Exhibit H

Recommended Regional Amendments to the 2018 International Swimming Pool and Spa Code

North Central Texas Council of Governments Region

ADD: Figure: 25 TAC §265.186 (e) (6)

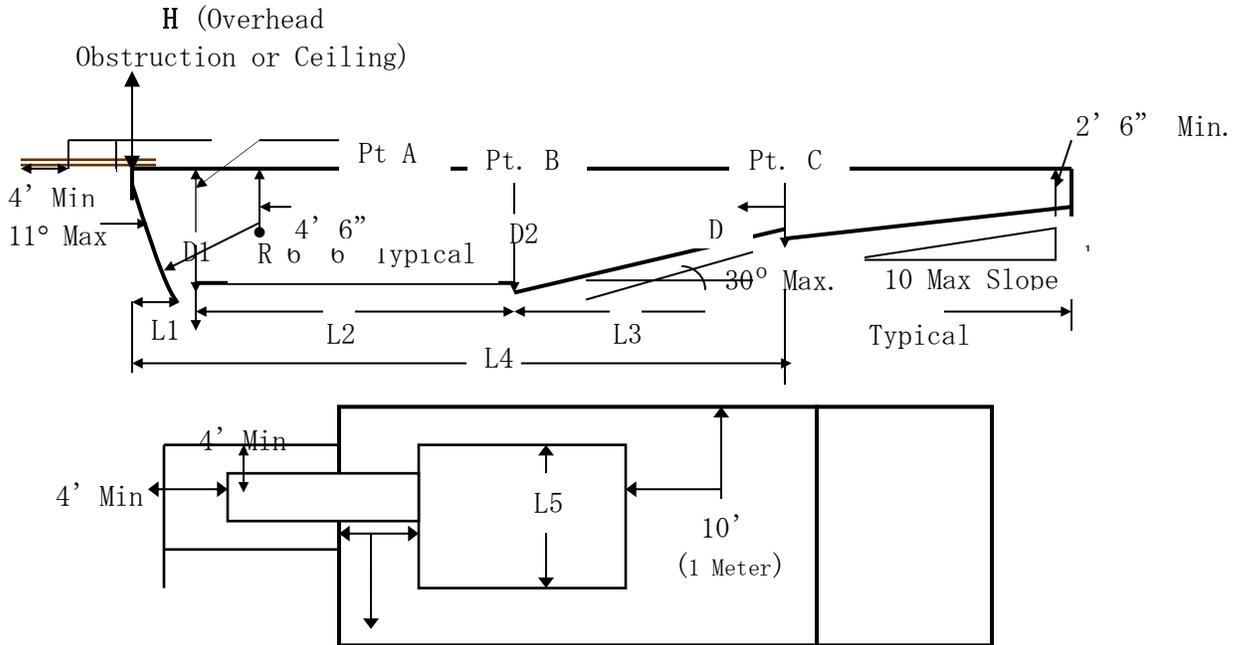
402.12 Water envelopes. The minimum diving water envelopes shall be in accordance with ~~Table 402.12 Texas department of State Health services, Administrative Code Title 25, Chapter 265, Section 186 (e) and Figure: 25 TAC 256.186 (e) (6).~~ (Delete Table 402.12 and Figure 402.12)

Maximum Diving Board Height Over Water	¾ Meter	1 Meter	3 Meters
Max. Diving Board Length	12 ft.	16 ft.	16 ft.
Minimum Diving Board Overhang	2 ft. 6 in.	5 ft.	5 ft.
D1 Minimum	8 ft. 6 in.	11 ft. 2 in.	12 ft. 2 in.
D2 Minimum	9 ft.	10 ft. 10 in.	11 ft. 10 in.
D3 Minimum	4 ft.	6 ft.	6 ft.
L1 Minimum	4 ft.	5 ft.	5 ft.
L2 Minimum	12 ft.	16 ft. 5 in.	19 ft. 9 in.
L3 Minimum	14 ft. 10 in.	13 ft. 2 in.	13 ft. 11 in.
L4 Minimum	30 ft. 10 in.	34 ft. 7 in.	38 ft. 8 in.
L5 Minimum	8 ft.	10 ft.	13 ft.
H Minimum	16 ft.	16 ft.	16 ft.
From Plummet to Pool Wall at Side	9 ft.	10 ft.	11 ft. 6 in.
From Plummet to Adjacent Plummet	10 ft.	10 ft.	10 ft.
